**TECHNICAL REVIEW OF WESTERN POWER'S
COMMENTS ON THE ECONOMIC REGULATION
AUTHORITY'S AA3 DRAFT DECISION.**

Prepared for

ECONOMIC REGULATION AUTHORITY

4 September 2012

Figure 2.1: Forecast Network Peak Demands (MW)

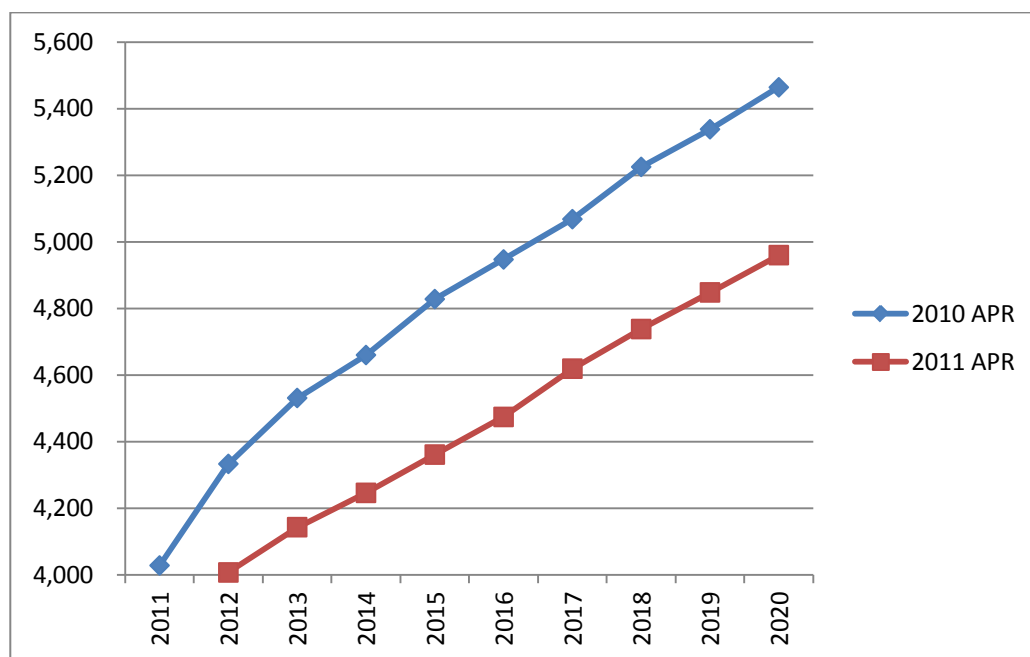
We further pointed out, with reference to Figure 2.1 below, that this is equivalent to three years' load growth and suggested that, all else being equal, this implies that the growth related capex for the final three years of AA3 is not required.

We accept the accuracy of Western Power's analysis and note that it is not at variance with our own assessment. What Western Power is suggesting is that there is little difference between the two forecasts in the *rate* of growth in demand during AA3. This is clear from Figure 2.1 above where, after 2012, the slope of the lines depicting the two forecasts is similar.
